Addendum 5
TFM-009-24 – GRD-508-23: Concrete & Asphalt Repairs 2024

PROJECT NAME:
CONCRETE AND ASPHALT REPAIRS 2024
Project #: GRD-508-23

Addendum 4
TFM-009-24 – GRD-508-23: Concrete & Asphalt Repairs 2024

DEMOLITION SITE PLAN
SCALE: 1:200

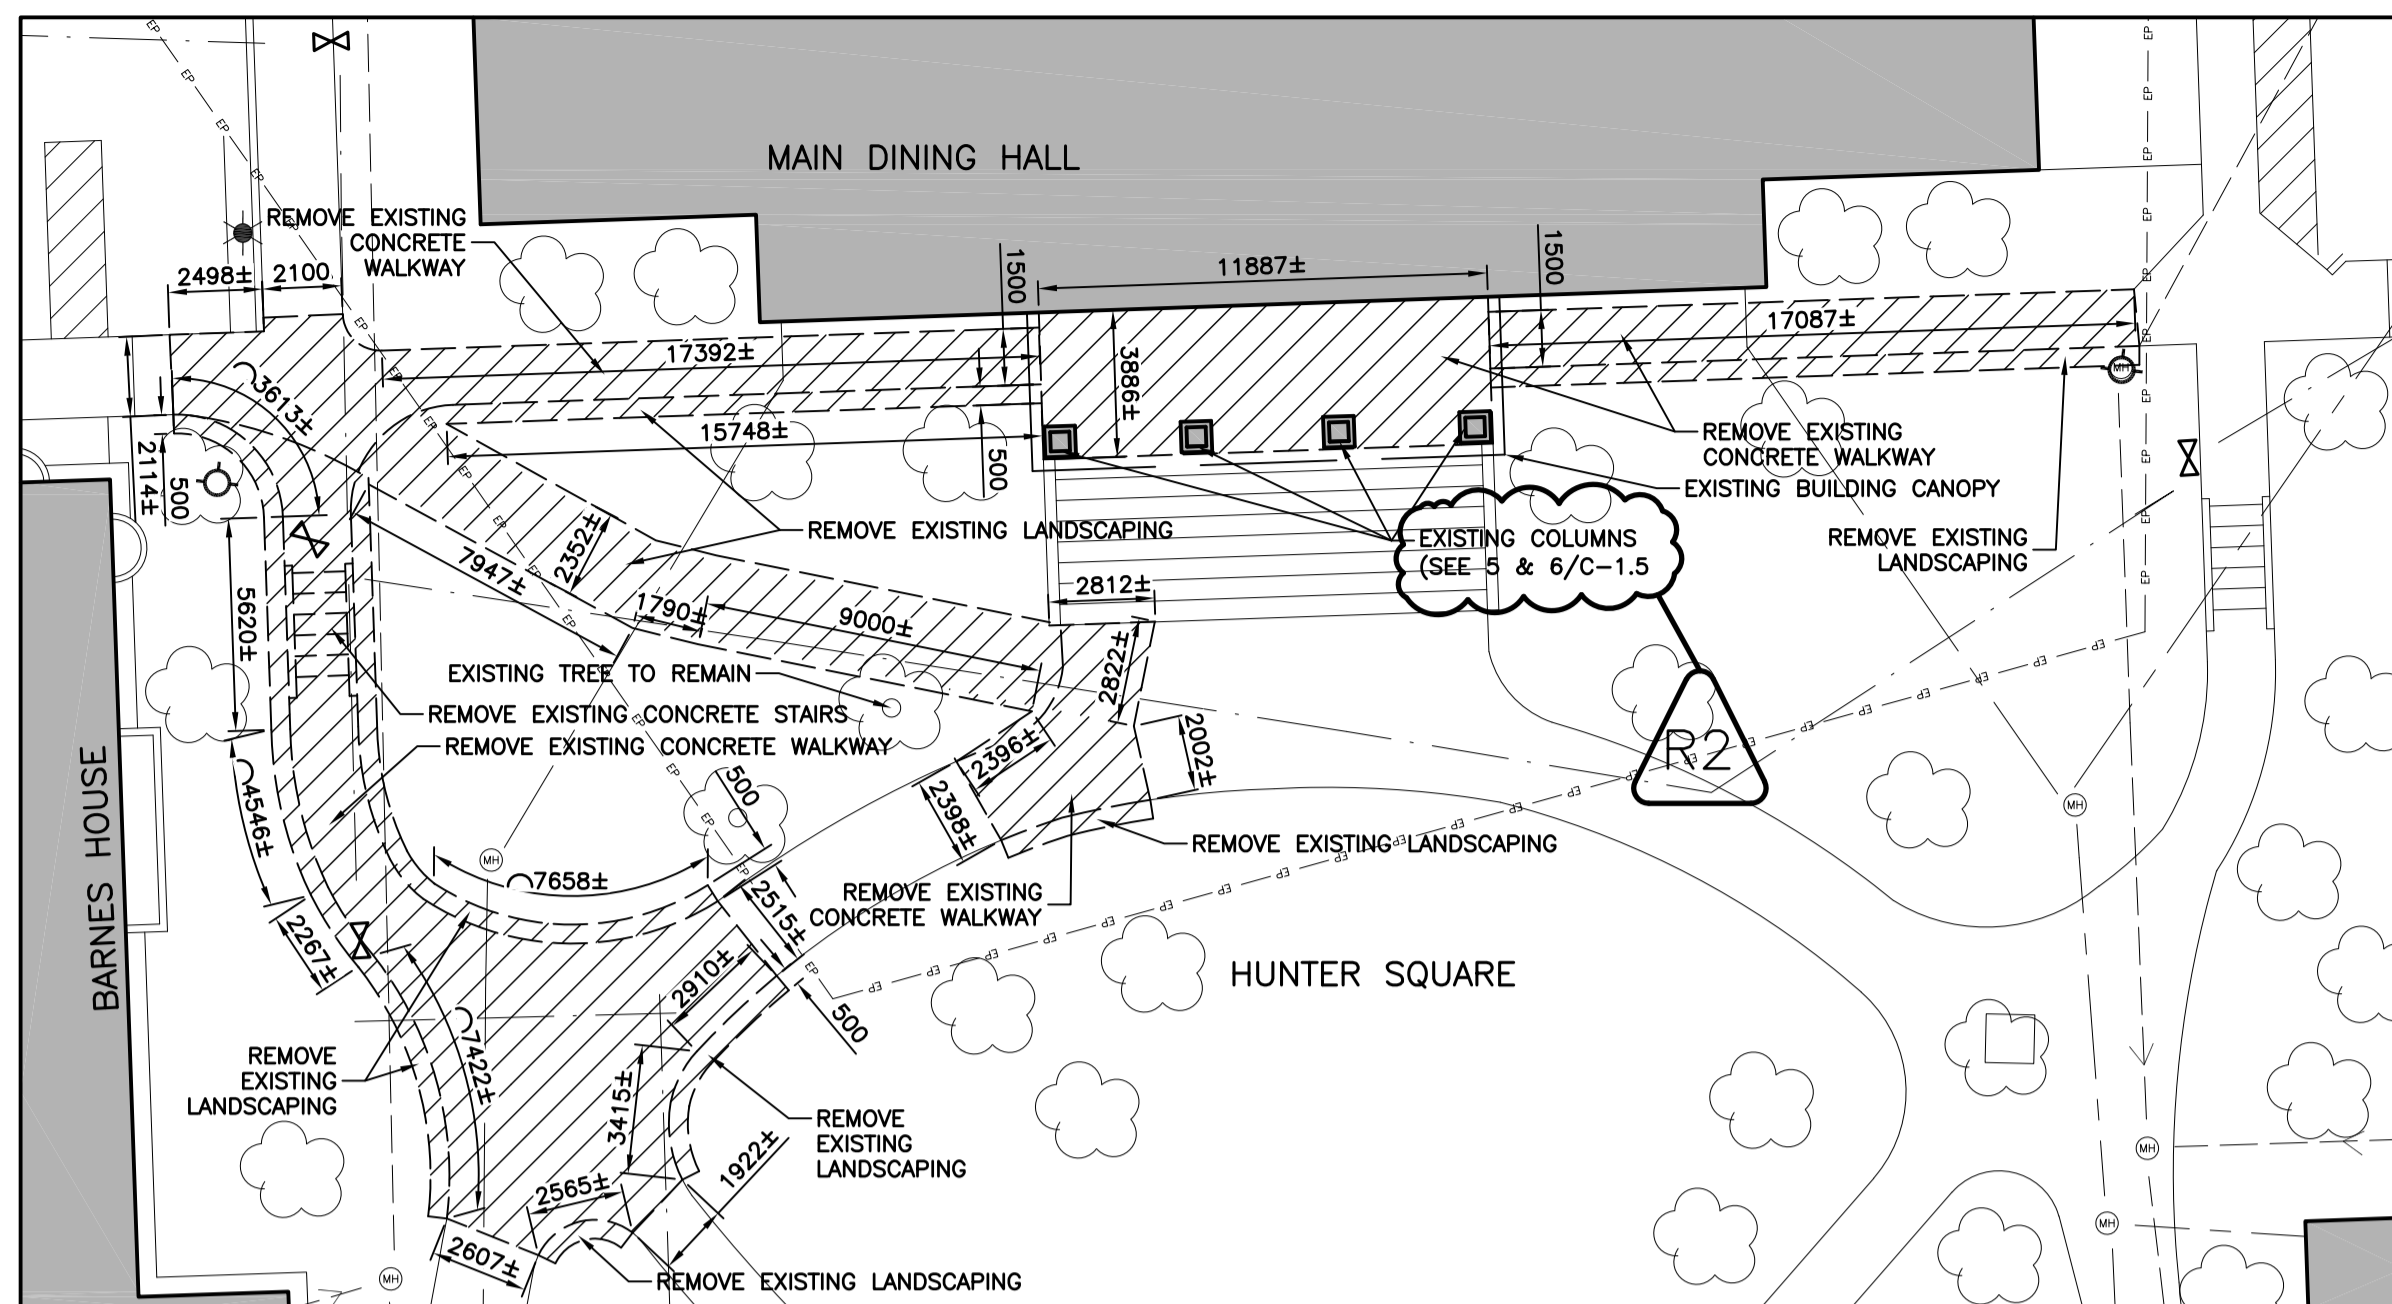
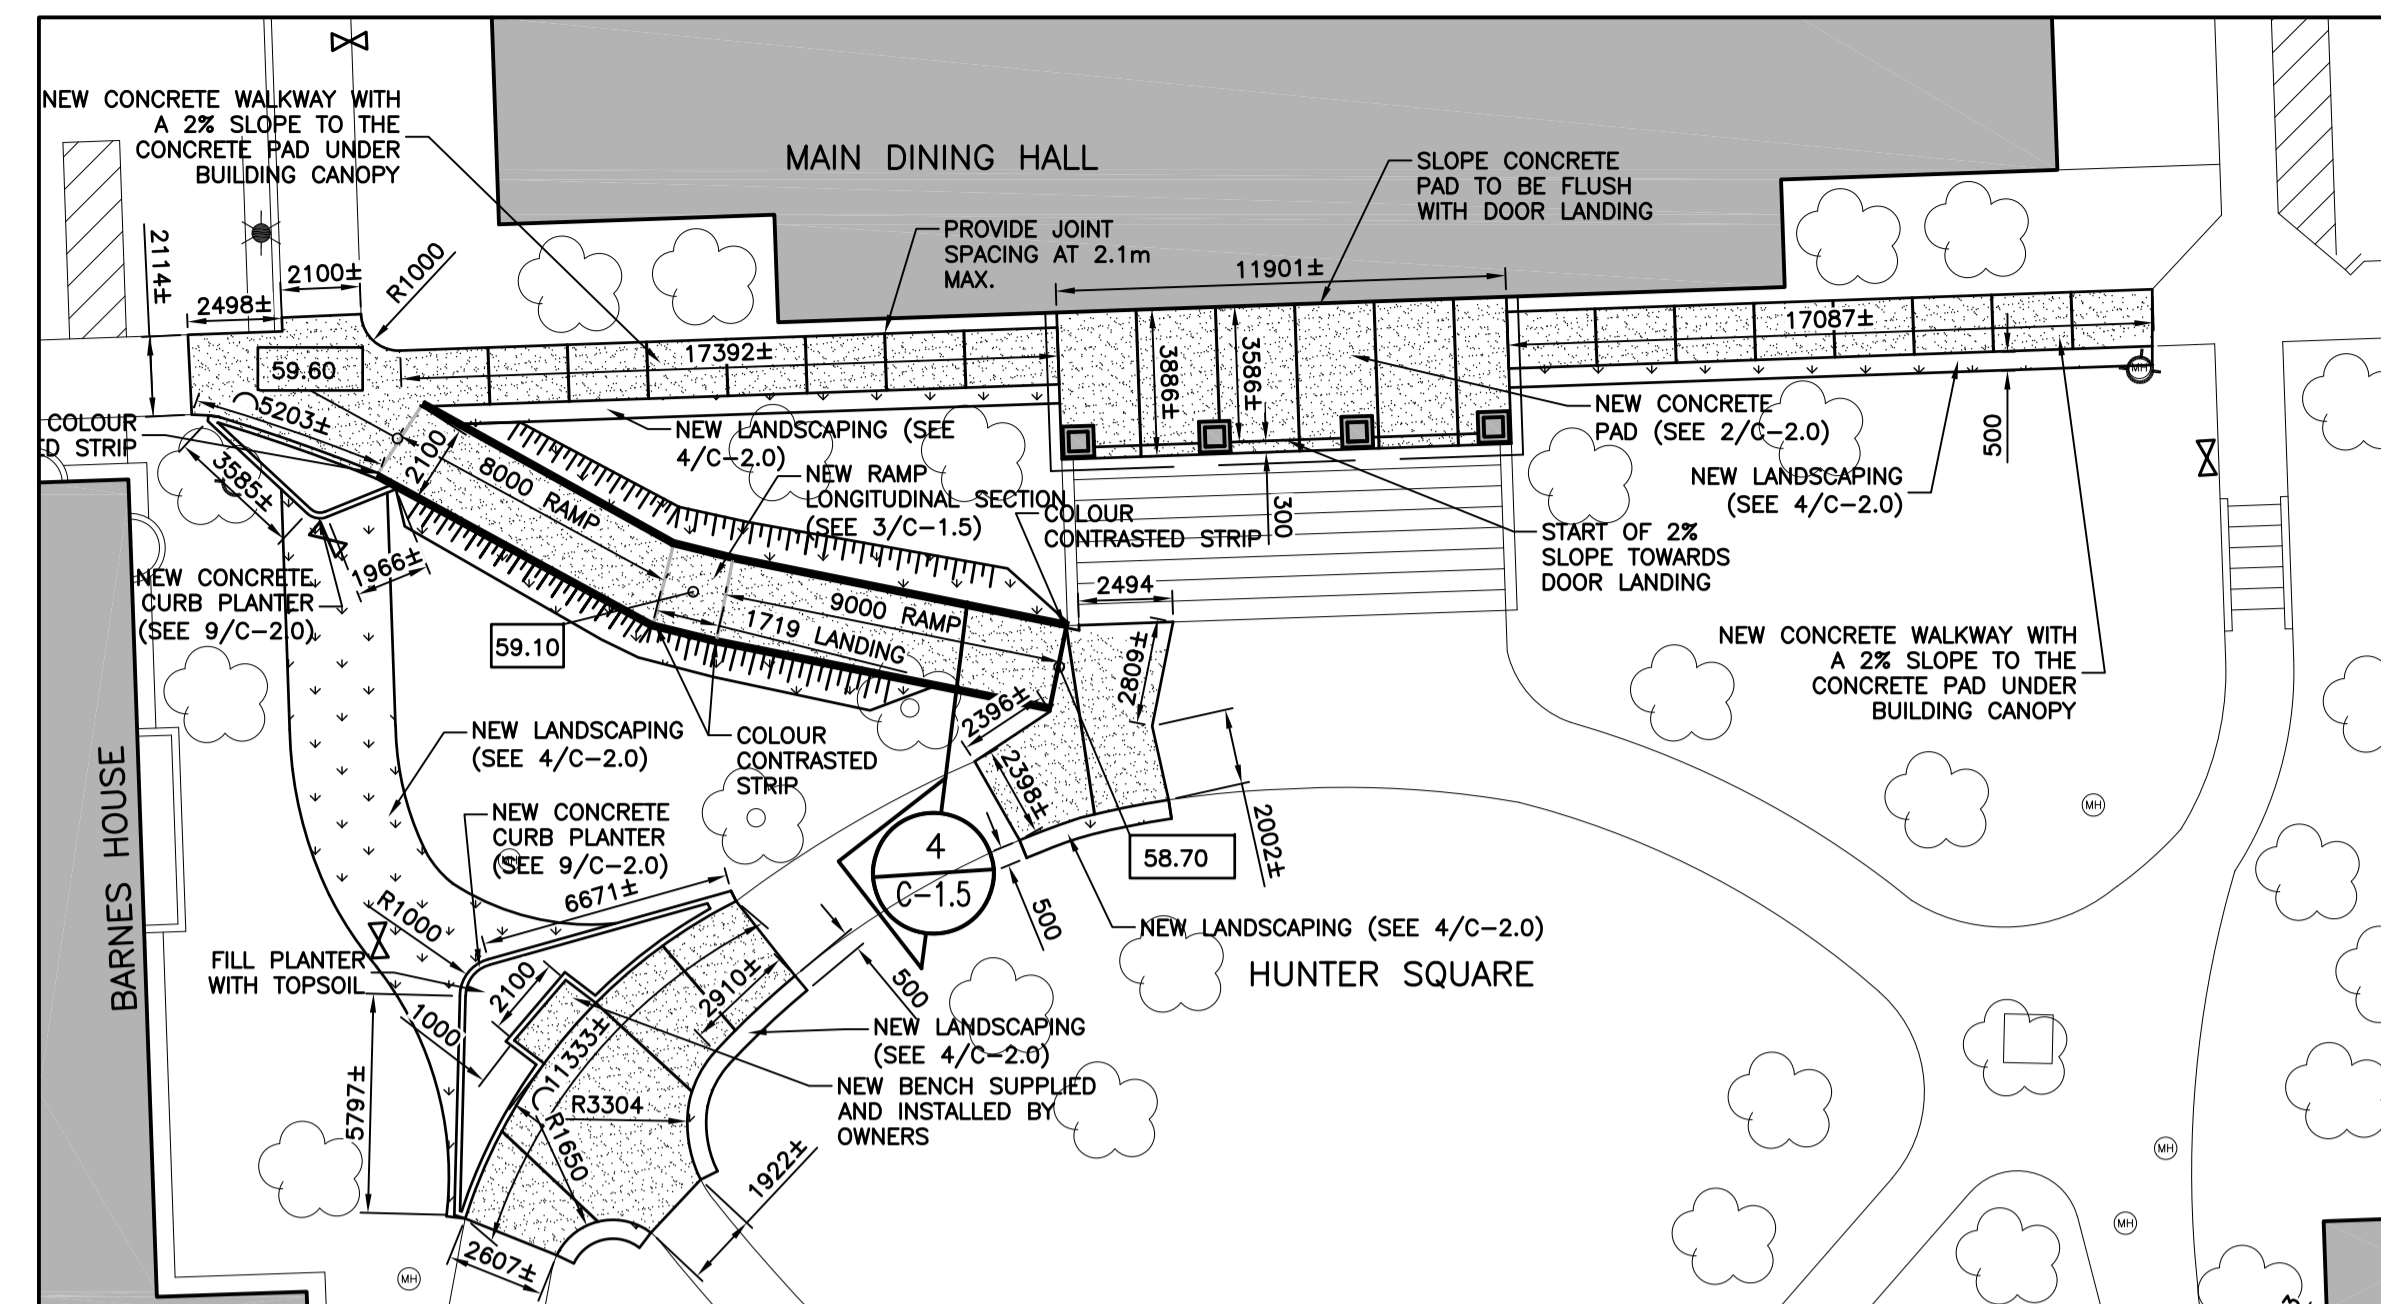
- .6 *C-1.5 2 says demolition site plan vs new site plan.*

RESPONSE: Drawing C-1.5 has been revised and reissued as part of this addendum.

NEW ELEVATION - RAMP
SCALE: 1:35

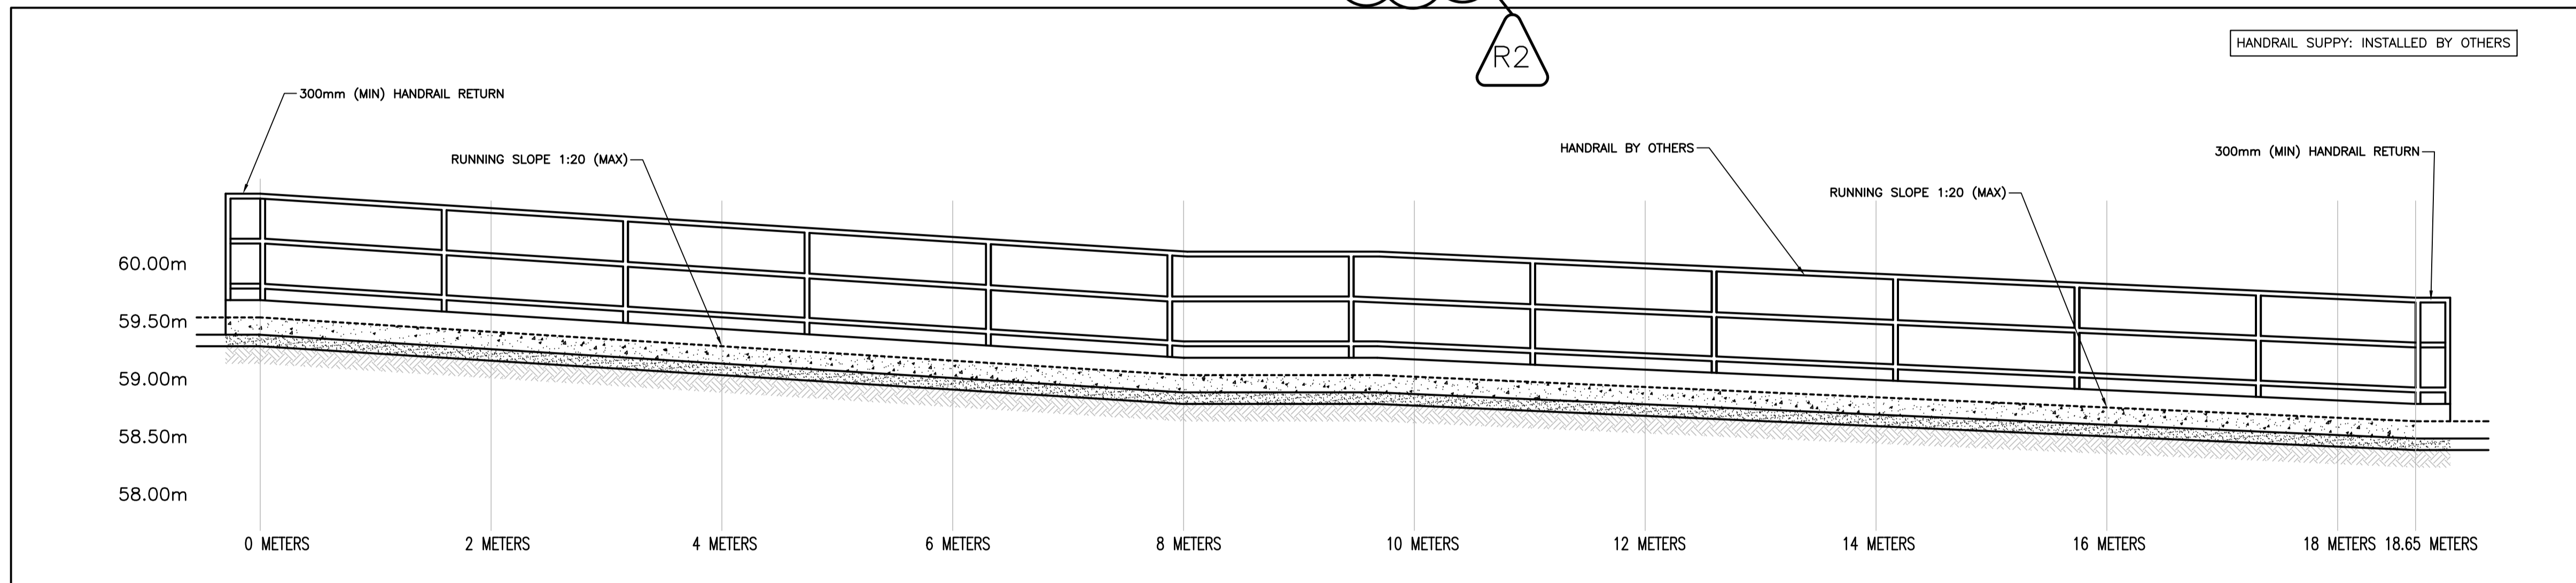
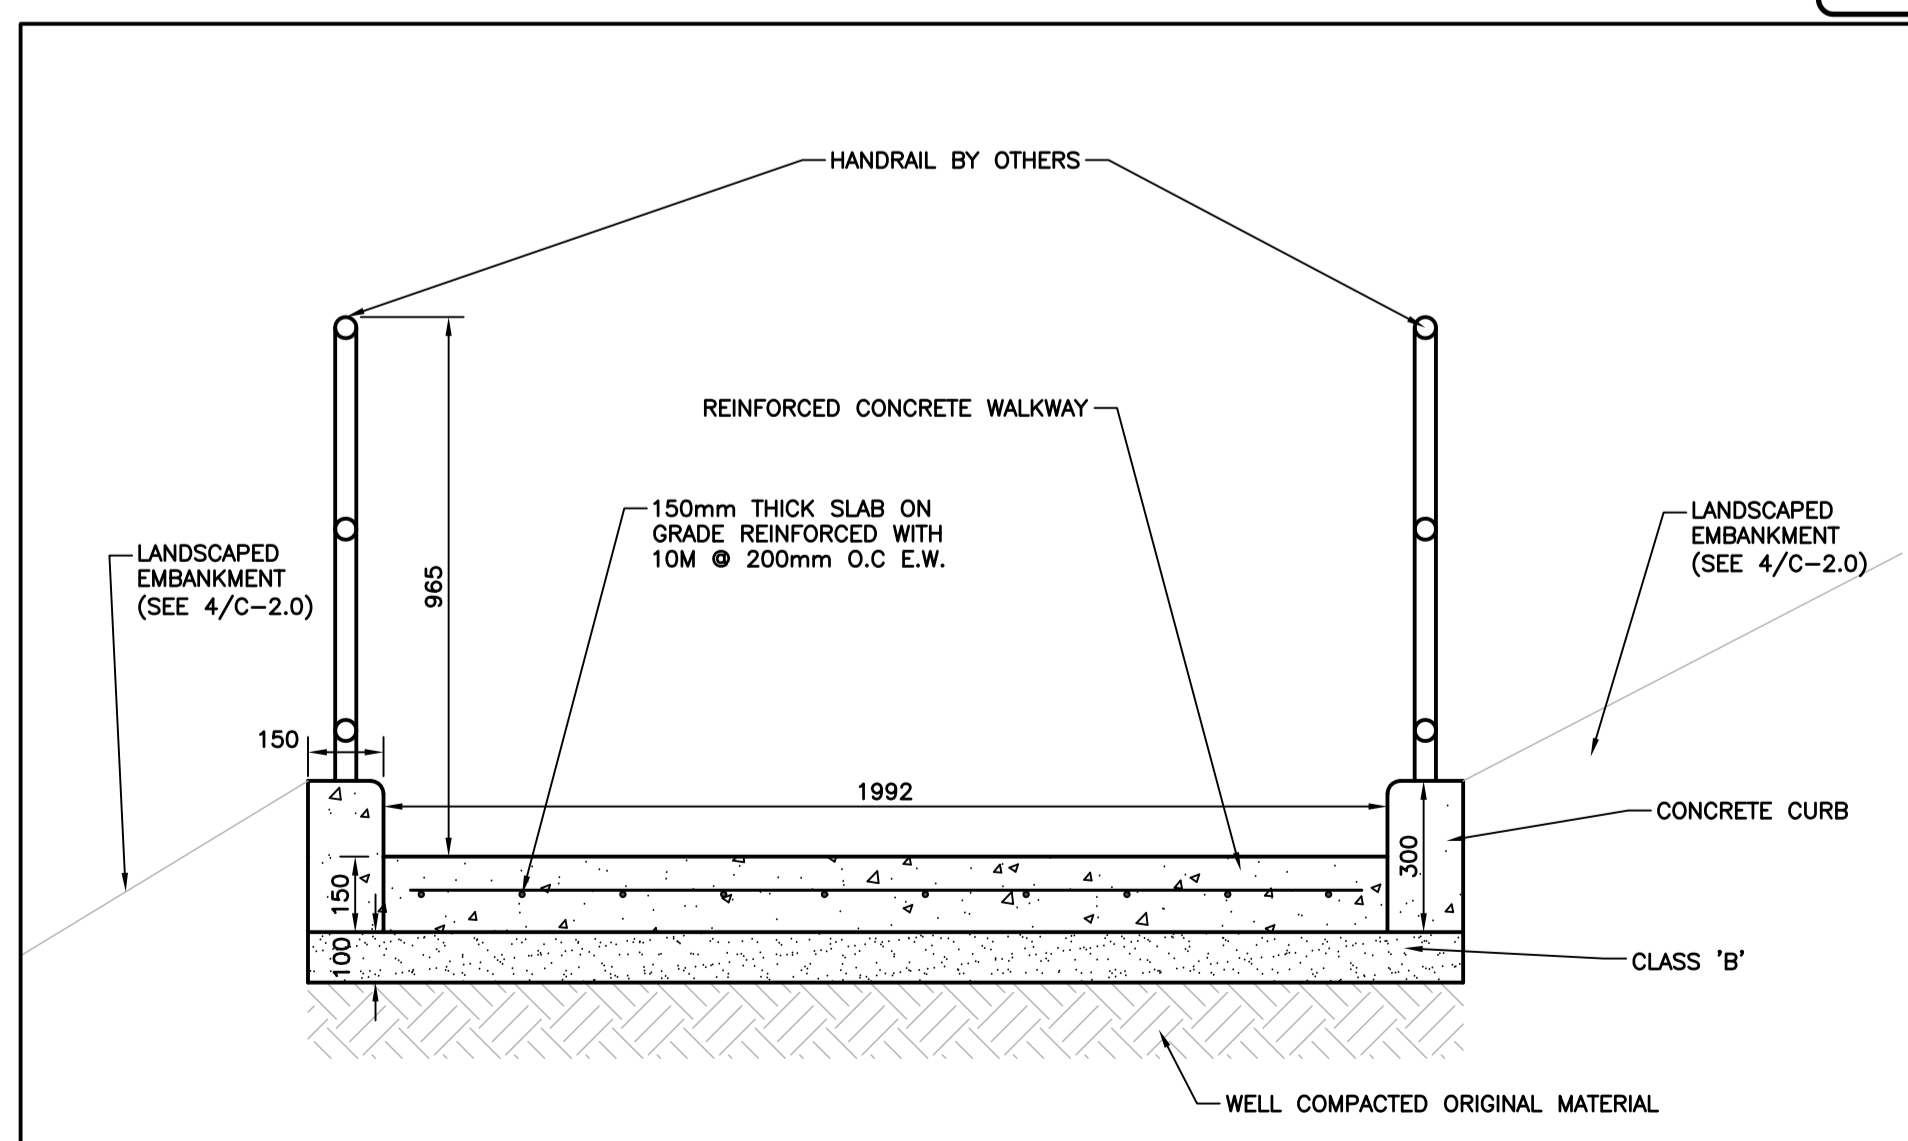
- .9 *The ramp area of C-1.5 1 runs into the existing tree route. Based on the path, there would be little option to remove organics without damaging the tree root system. Is there any thought to creating the ramp over the existing pathway that would now be landscaped (left of the drawing area). The ramp could be L shaped or other to still route to the proposed landing.*

RESPONSE: Accessibility requirements for the ramp cannot be achieved using the existing pathway route. After award the contractor may propose, to the owner, a detailed shop drawing with *minor* modifications to the ramp layout to avert the removal of vegetation. Please bid as per the IFT documents.
